**AGENDA
CITY OF CEDAR FALLS, IOWA
PLANNING AND ZONING COMMISSION MEETING
WEDNESDAY, JANUARY 13, 2021
5:30 PM AT CITY HALL VIA VIDEOCONFERENCE**

TO: Planning & Zoning Commission
FROM: Michelle Pezley, Planner III
 Matthew Tolan, EI, Civil Engineer II
DATE: January 6, 2021
SUBJECT: Arbors Fourth Addition Final Plat

TO: Planning and Zoning Commission
FROM: Jaydevsinh Atodaria (JD), Planner I
 Matthew Tolan, Civil Engineer II
DATE: January 7, 2021
SUBJECT: Pinnacle Prairie Commercial South, Phase III, Second Addition Final Plat

TO: Planning and Zoning Commission
FROM: Jaydevsinh Atodaria (JD), Planner I
 Matthew Tolan, Civil Engineer II
DATE: January 7, 2021
SUBJECT: Pinnacle Prairie Senior Living Site Plan (SP20 – 011)

Arbors Fourth Addition Final Plat

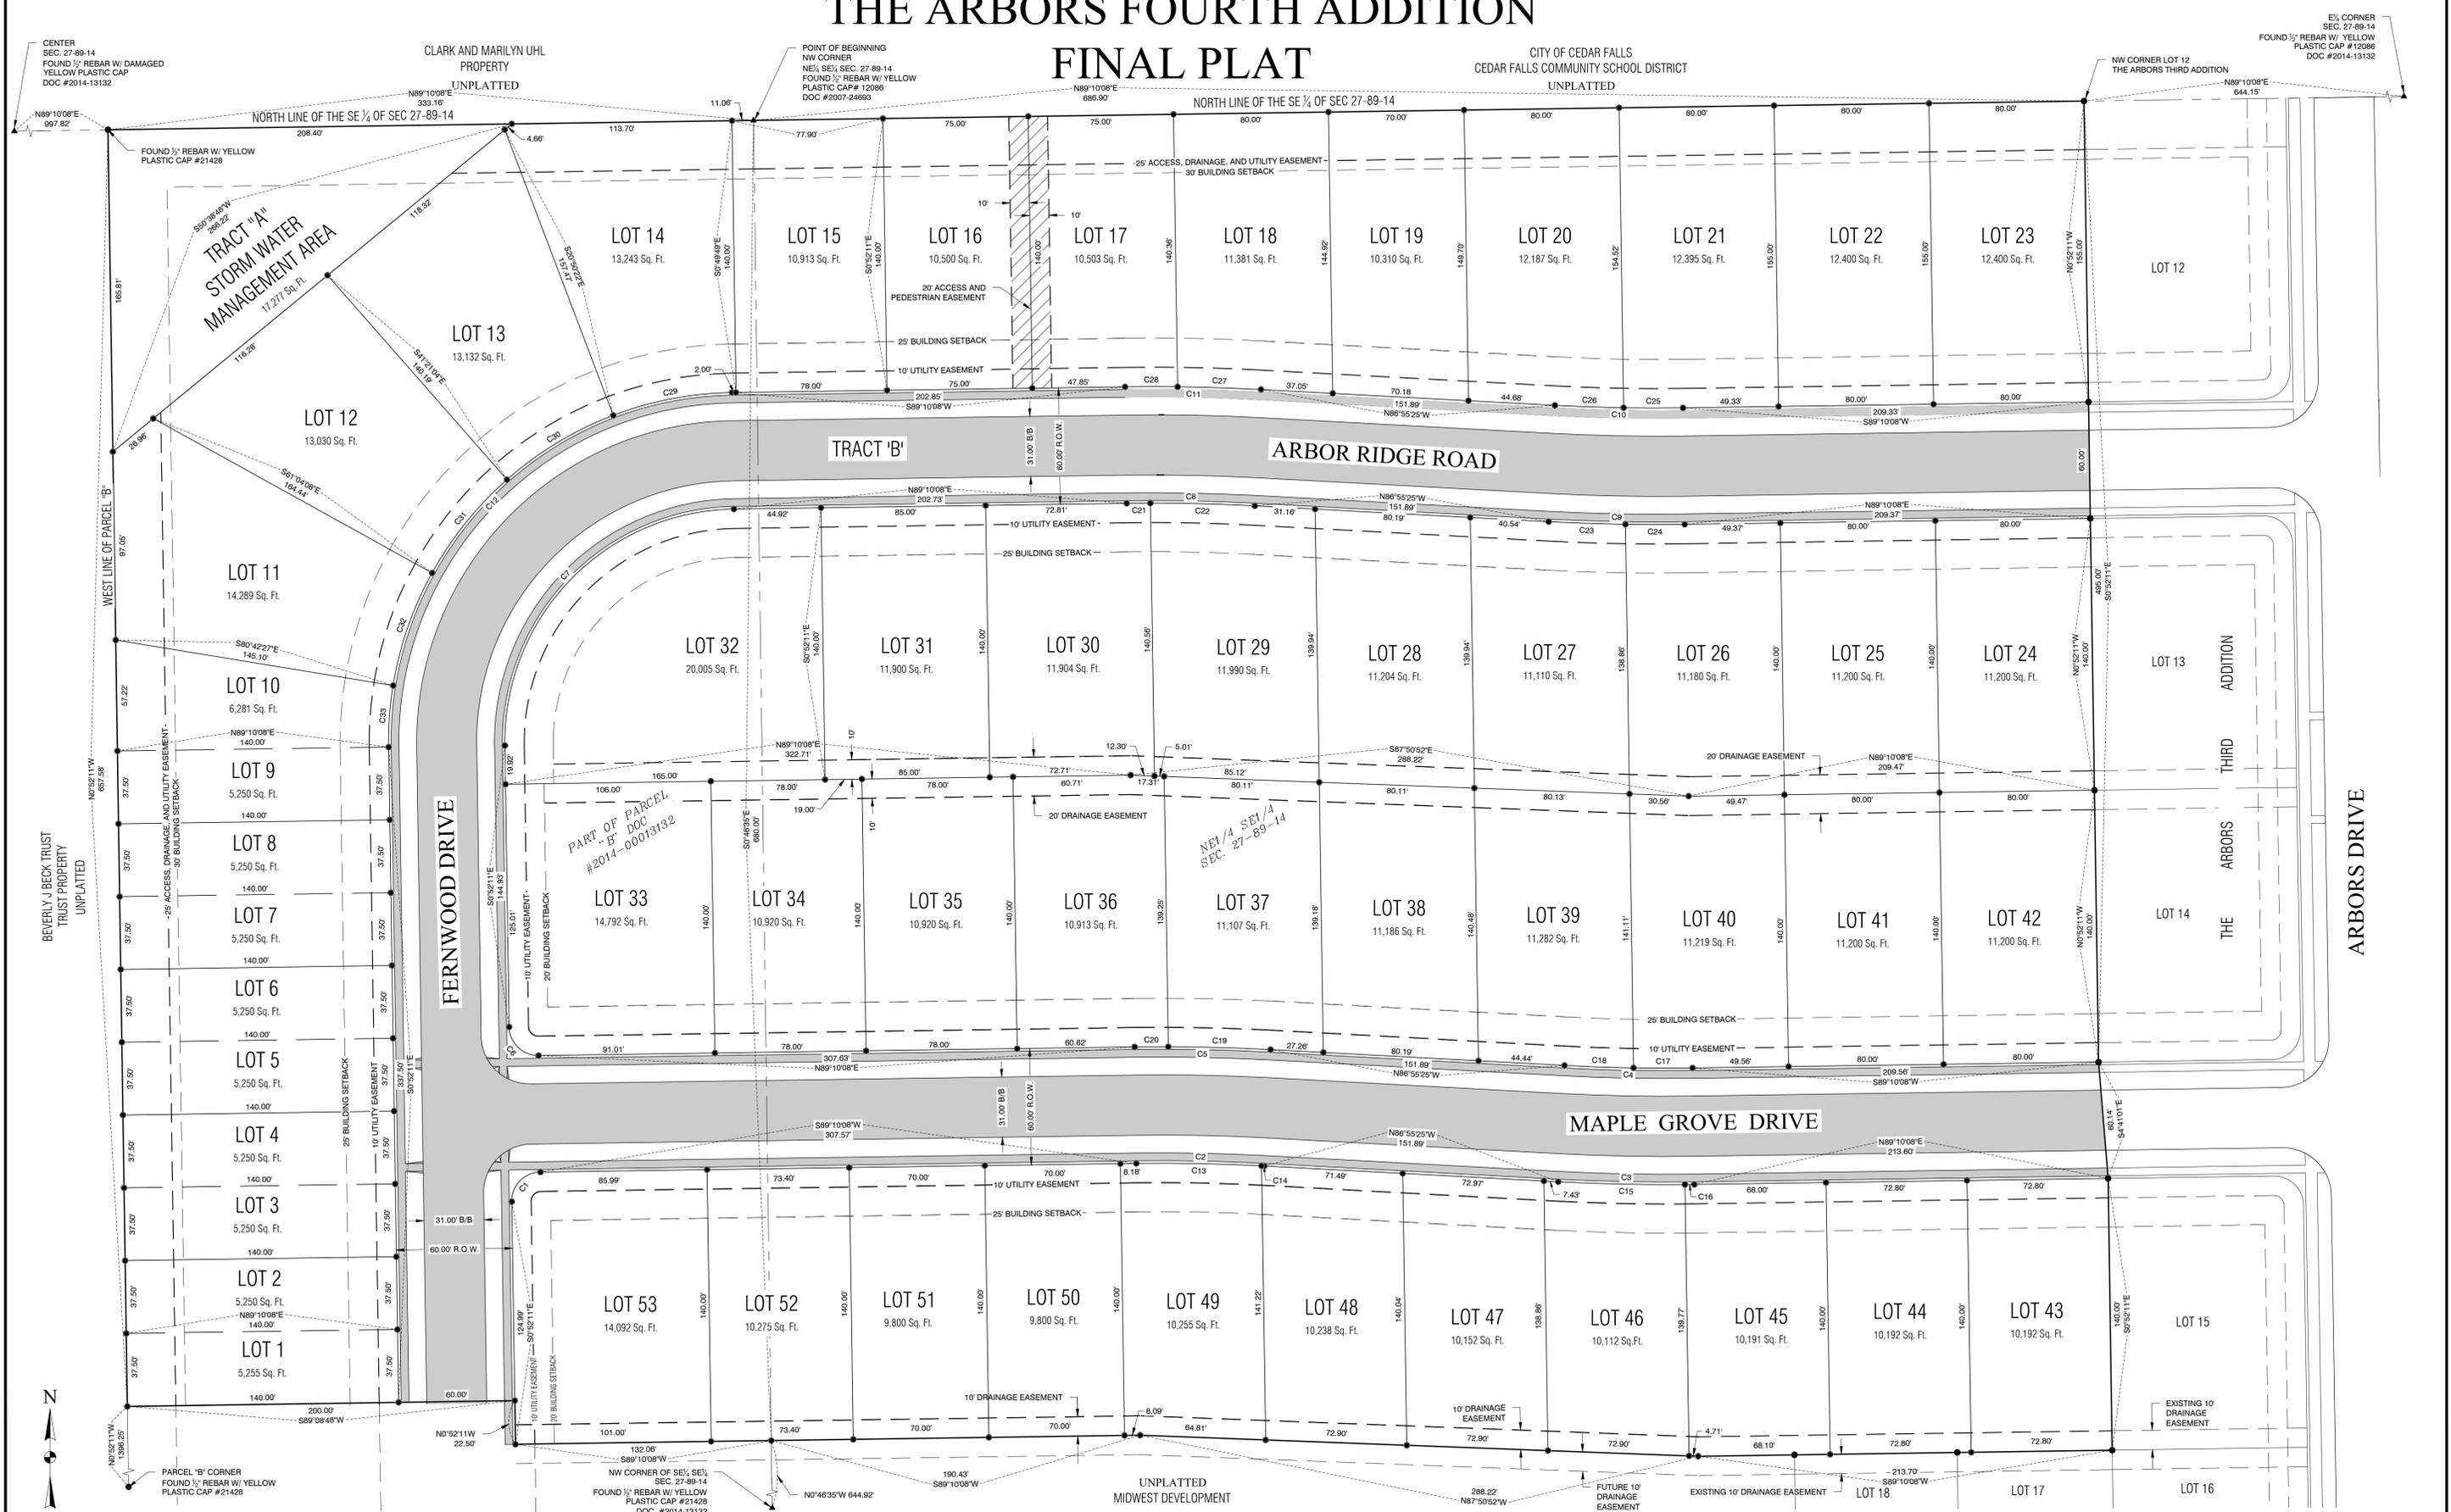
As required from the preliminary plat process, the plat shows a pedestrian connection through a 20 foot wide easement that extends along the lot line between lots 14 and 15 to accommodate a sidewalk connection from Arbor Ridge Road to the future public park on the north side of the subdivision. During review of the final plat, staff noted that the pedestrian connection as proposed between lots 14 and 15 was located too far to the west to provide access to the park. The petitioner agreed to move the pedestrian access to the east and a revised plat has been submitted that shows that the pedestrian connection between lots 16 and 17.

NO.	REVISION	BY	DATE	NO.	REVISION	BY	DATE
1	REVISE PEDESTRIAN EASEMENT	SJC	12-23-2020

SITE PLAN PINNACLE PRAIRIE SENIOR LIVING IN THE CITY OF CEDAR FALLS BLACK HAWK COUNTY, IOWA

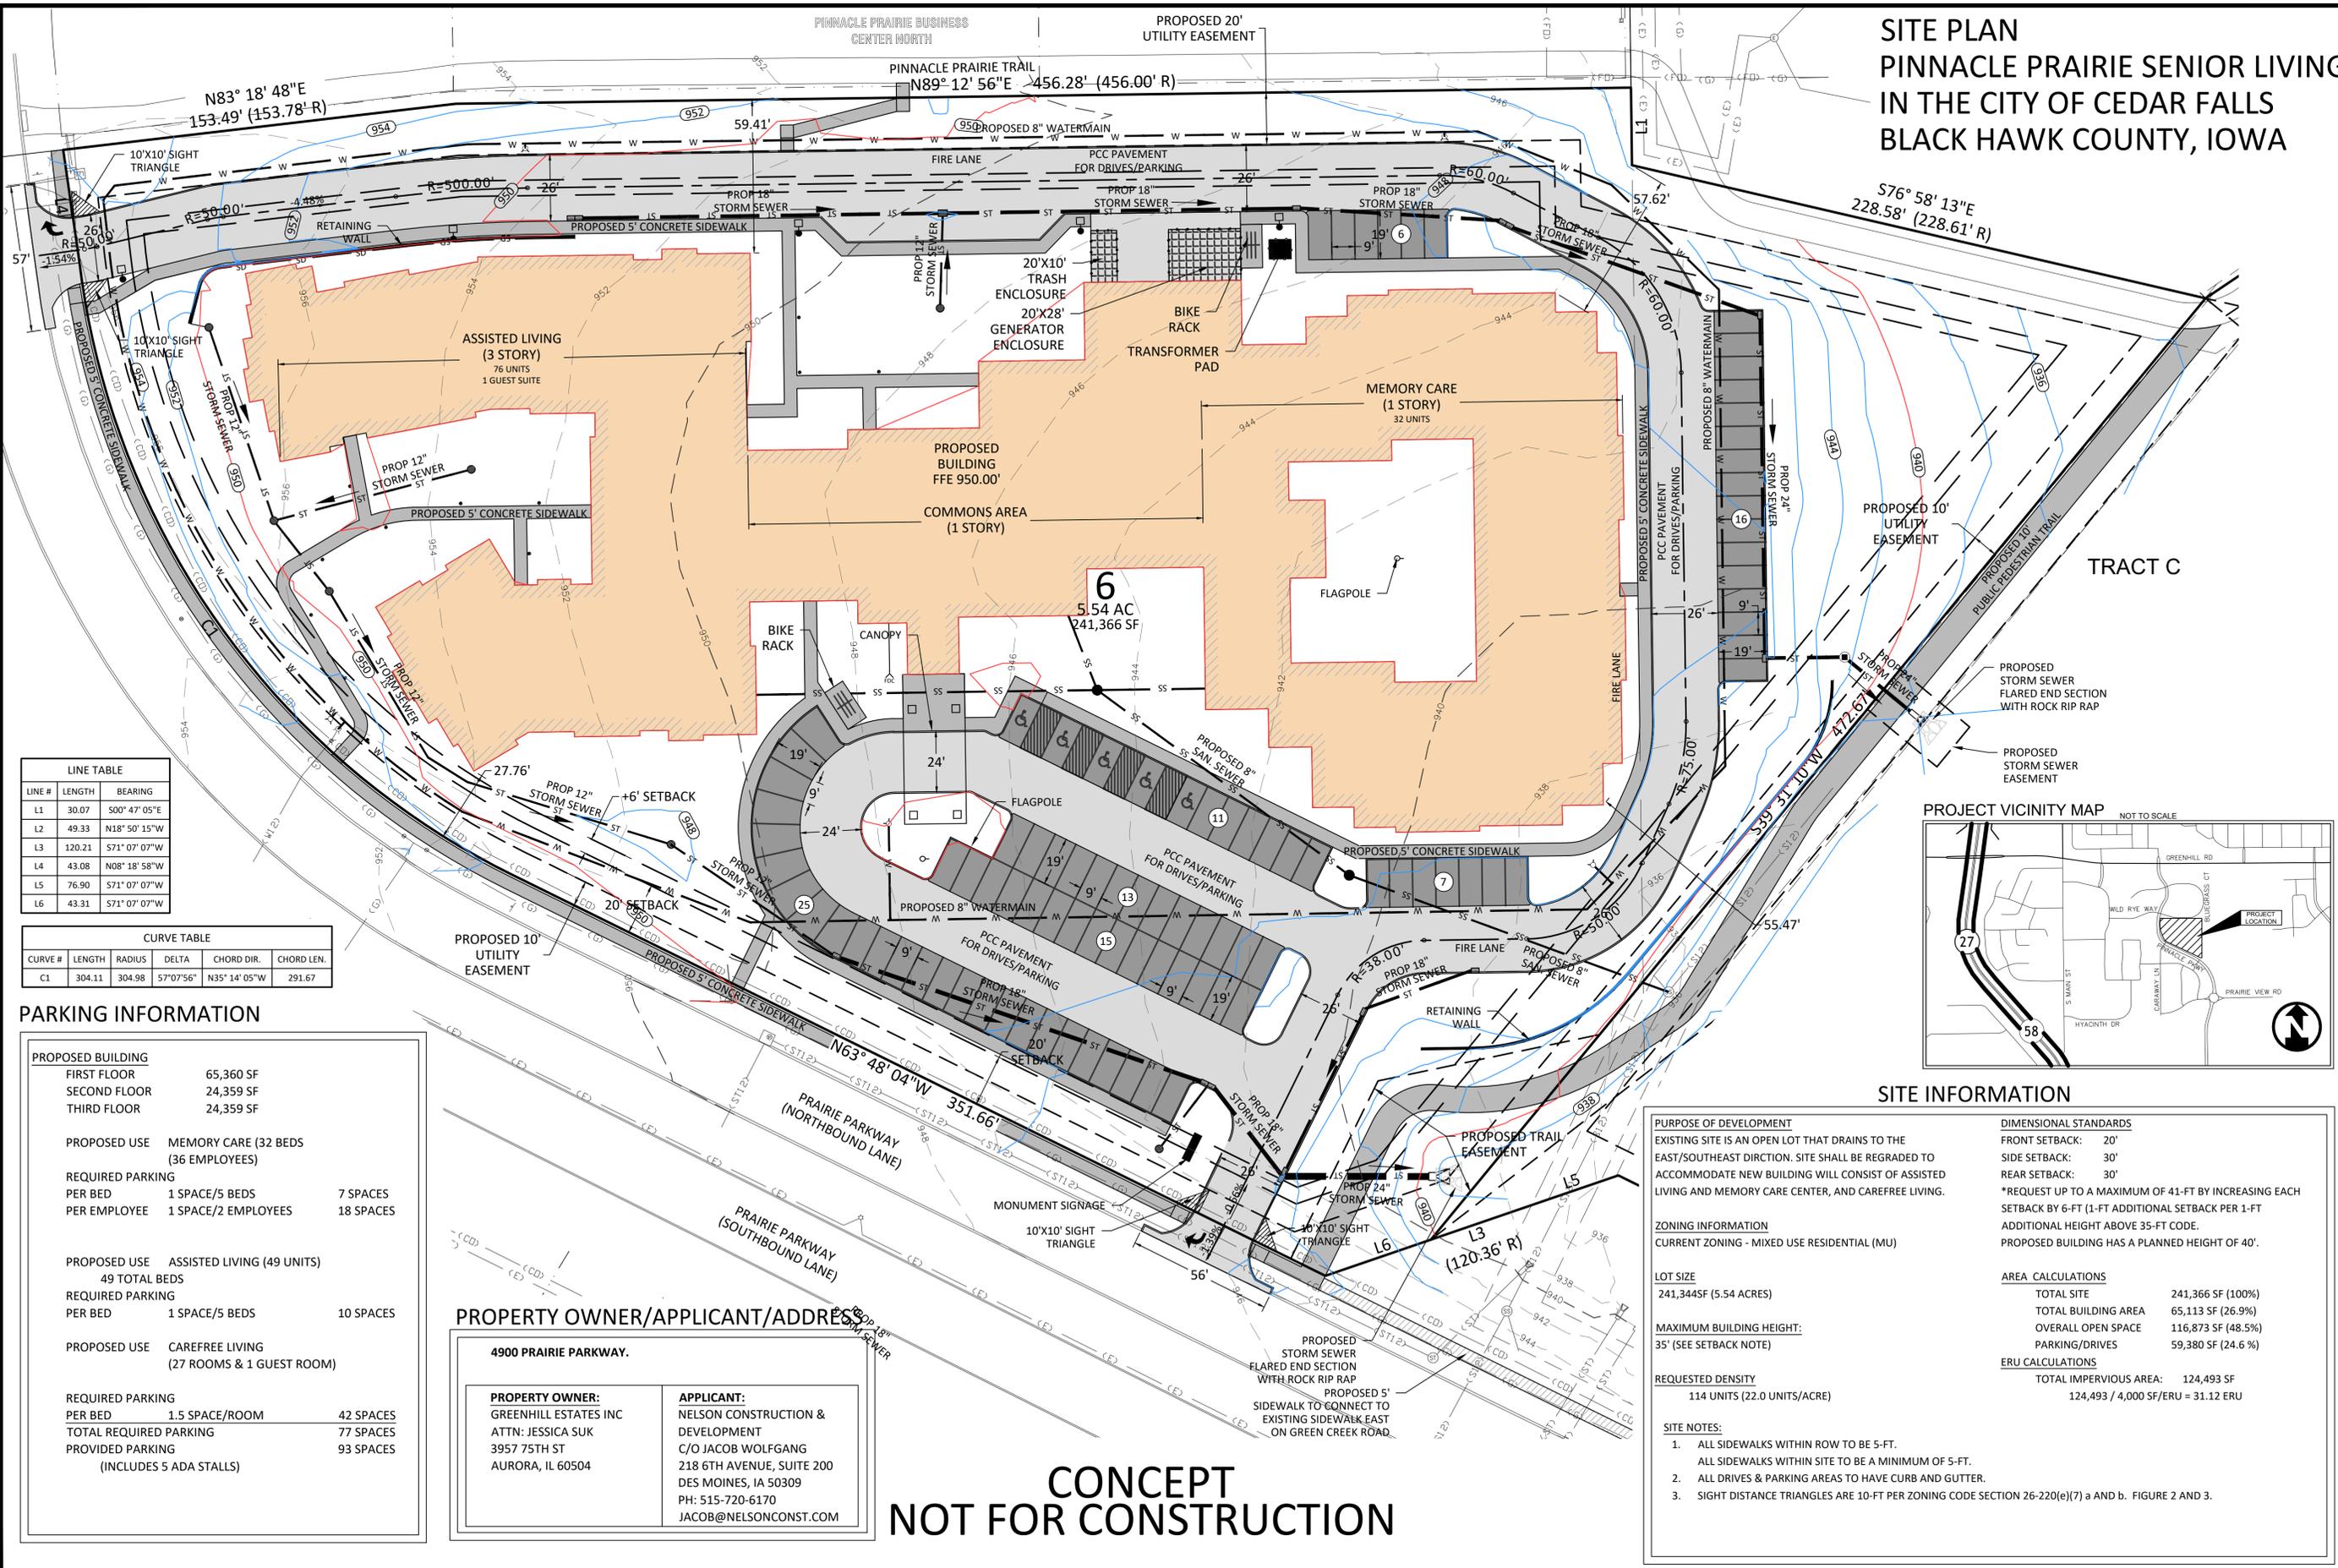
Mr. Holst commented that there were letters received right before the meeting from neighbors who had concerns with the project. Ms. Lynch asked if there has been any traffic study done in the area with regard to the median. Ms. Howard stated that it was studied when the design was originally done and was noted in the master plan that this lot would only have right in/right out traffic.

Mr. Leeper asked if the project meets the requirements for visibility and distance from intersections as those concerns were stated in the letters. Ms. Howard stated that it was studied at the time the master plan was approved and that more information can be brought back from the city engineer at the next meeting.

Secondly, I would question the traffic exiting the property from either entrance. Again, it appears their only option would be a RH exit onto Prairie Parkway and leaving those with a desire to go south an issue of doing a U-turn somewhere, likely the intersection of Wild Rye Way/Bluegrass Cir and Prairie Parkway. Another intersection with limited visibility and heavy traffic, not conducive to U-turn traffic.

This type of high density senior living located on Prairie Parkway at this location is concerning the traffic visibility issue that we live with on a daily basis in this area. Traffic coming from the south out of the roundabout is traveling at a posted 35 MPH, with many going much faster as they are coming from the Viking area shopping area. I see that this plan shows two driveways included in this plan and they are positioned in the S curve area of Prarie Parkway. The north driveway is placed right next to the walking trail that crosses Prairie Parkway. There is no visibility at present to maneuver

Site is equipped with two driveway locations for the site. Both the driveways are off of Prairie Parkway and are right-in / right-out only because there is a median along Prairie Parkway that prevents full access. The master plan anticipated this limited access. The driveway leading to main entrance area is located in the southwest corner of site.
